LOS MEDANOS ENERGY CENTER, LLC

RE: Los Medanos Energy Center (98-AFC-01C): Petition for Modification
Mineralization and Carbon Capture Project—Responses to Data Requests Set 1

**LOS MEDANOS ENERGY CENTER (98-AFC-01C)
PETITION FOR MODIFICATION
MINERALIZATION AND CARBON CAPTURE PROJECT
RESPONSES TO CEC STAFF'S DATA REQUESTS SET 1**

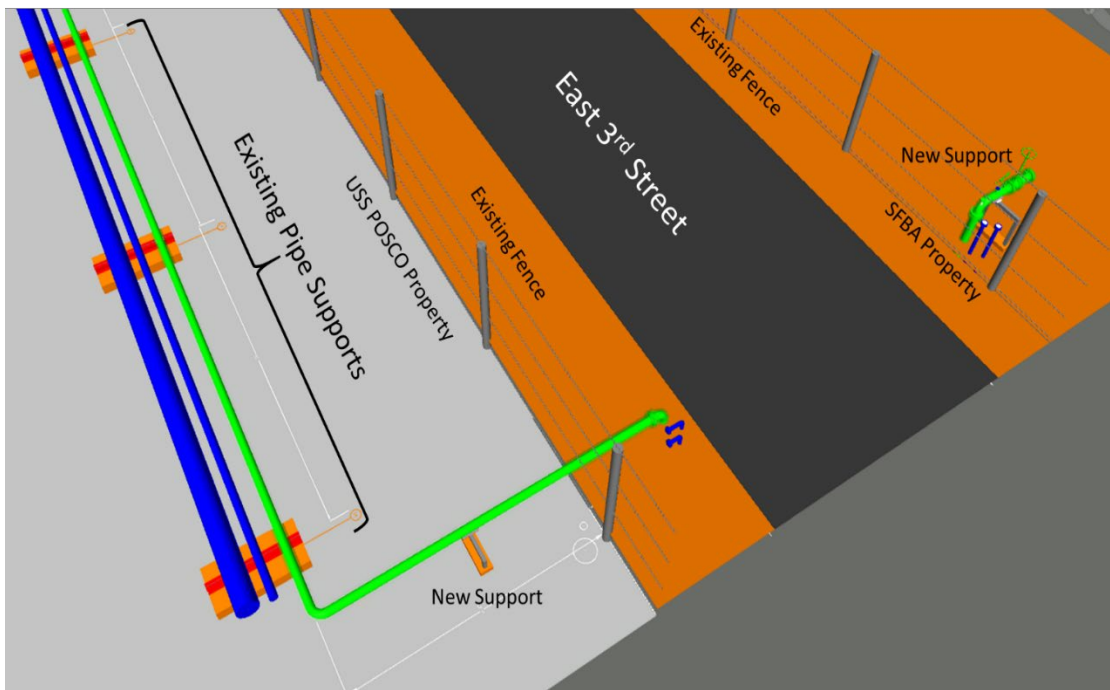
a) Please describe the new pipe racks/supports to which the 8-inch gas pipe will be attached.

RESPONSE: The new pipe supports will be constructed on existing structures. Two supports for the new 8-inch pipeline will be located near the stack tie-in. These supports will be located on an existing portion of structure. The supports are positioned in a location that will support the run of 8-inch pipe from the stack to the existing pipe racks.

With the underground road crossing, two new support structures located in the immediate vicinity of the East 3rd Street crossing will be installed. These are shown below. One of those supports is located just inside the fence line on USS POSCO property. The second support structure is located on SFBA property on an existing concrete pad.

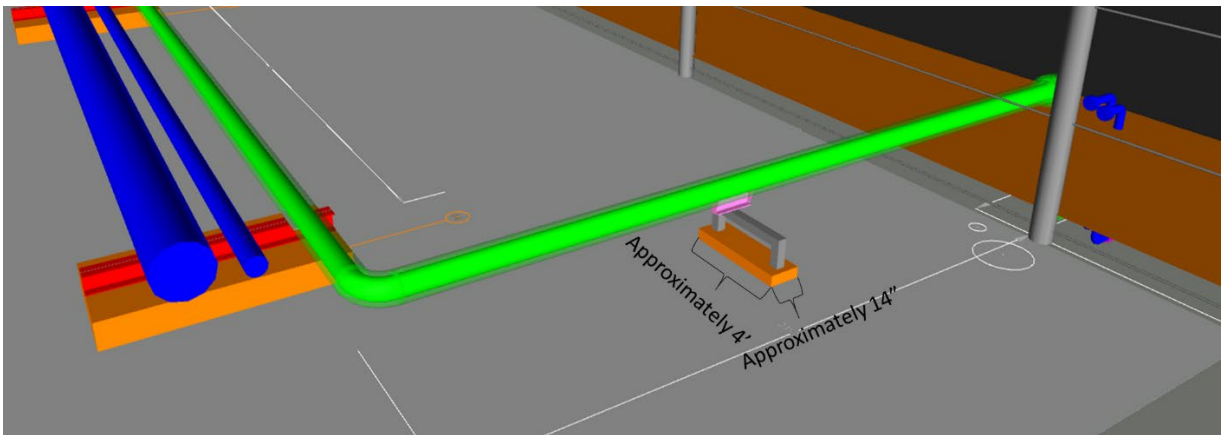
- c) *Please describe how the new sections of pipe rack/supports would be installed and specifically, how that is accomplished without ground disturbance. If ground disturbance is required to install the new sections of pipe rack/supports, please identify the number and extent of horizontal and vertical excavations that would be required to install the pipe racks/supports, the ground surface to which they will be attached or mounted, and*

any below-grade elements that would be required for the installation of the pipe racks/supports.

RESPONSE: Within the LMEC fence line, new sections of pipe will be installed on existing structures using clips and brackets. No additional welding is anticipated for these new attachments. Once the pipe leaves the LMEC fenceline, it will run along LMEC's existing pipe support racks, with the exception of the two new supports described above. The pipe support on USS POSCO property will require ground disturbance of approximately 4 feet in length, 14 inches wide, and installed to the same ground surface as the existing pipe supports. As noted above, in addition to the 8-inch insulated pipe, two additional 2-inch pipes will be installed under East 3rd Street as well. These lines are for future, as-yet undetermined use, and are intended to minimize impacts to the traffic on East 3rd Street, which is a privately owned road.

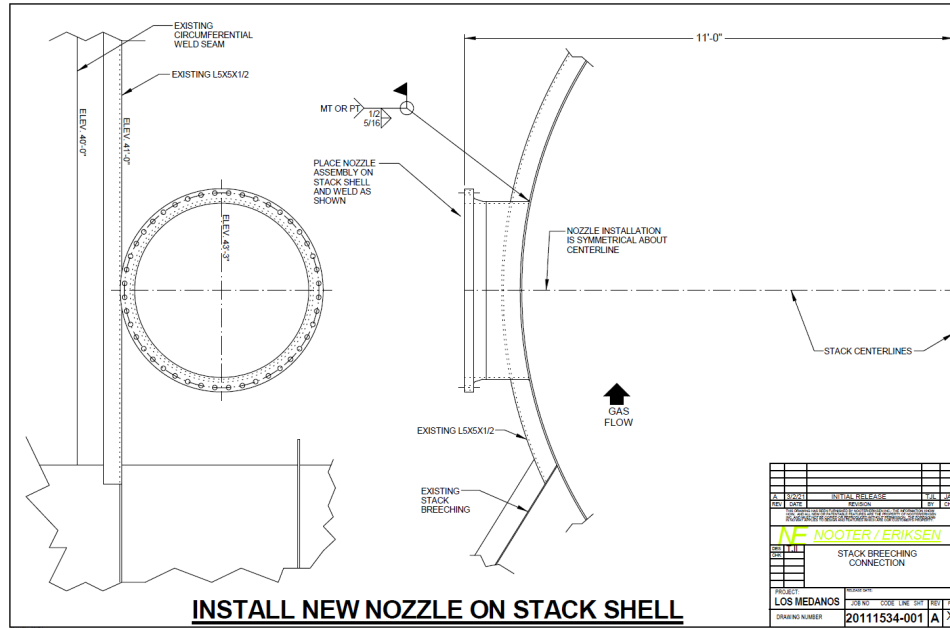
A2. *Please provide a figure depicting the new 8-inch pipe where it would interconnect to the stacks and its relationship to the surface at grade or confirm the specifications on Sketch 1. Sketch 1 seems to indicate the connection to be at 34-feet 2-inches above grade and sloping generally at 1/8-inch per foot.*

RESPONSE: As shown below, the stack tie-in is a 48-inch nozzle with a centerline approximately 43 feet and 3 inches above grade. Regarding the 1/8-inch sloping per foot, this is a design feature to minimize condensate collection in the pipe. During normal operation, the flue gas temperature is well above the dewpoint and condensation will not be an issue. However, in the event some condensate collects during shutdown, the piping

from the stack to the damper valve (which is for isolation) is designed to be self-draining back to the stack where it will be vaporized by the exiting flue gas.

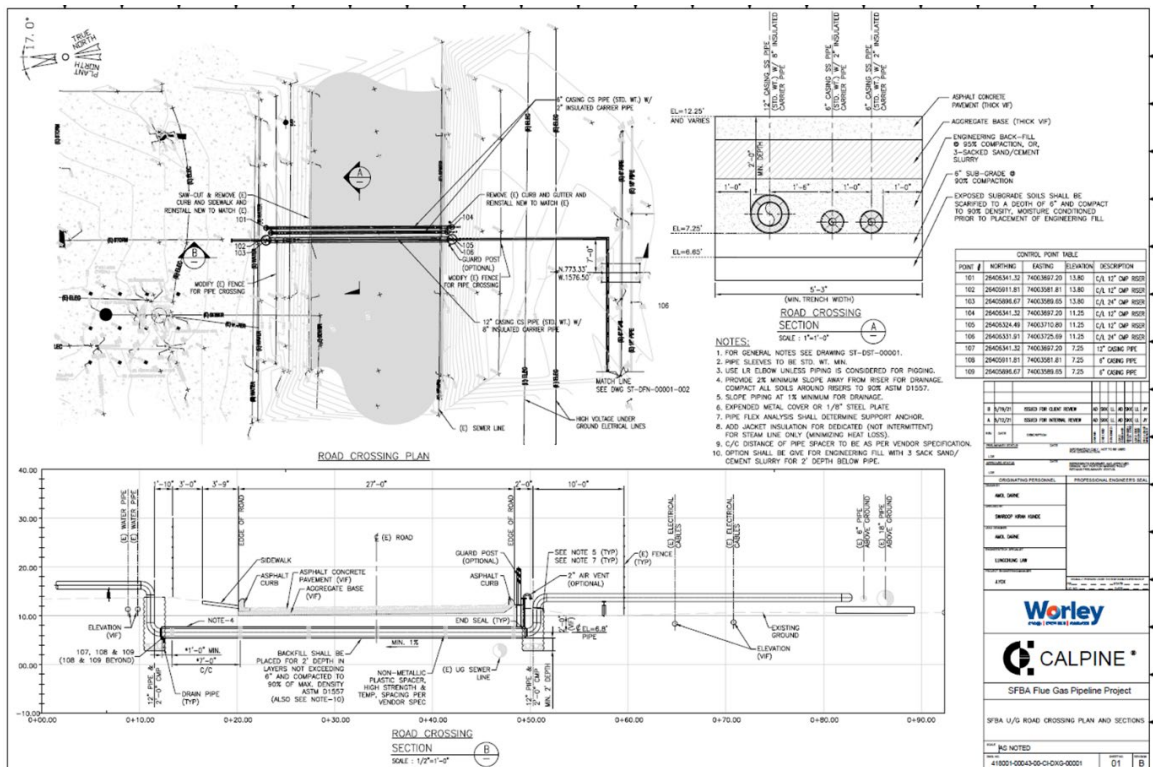
A3. Please provide a site plan on an aerial base that shows the new 8-inch pipe connection at the stack and the entirety of the pipe line to the connection at the adjacent property.

RESPONSE:
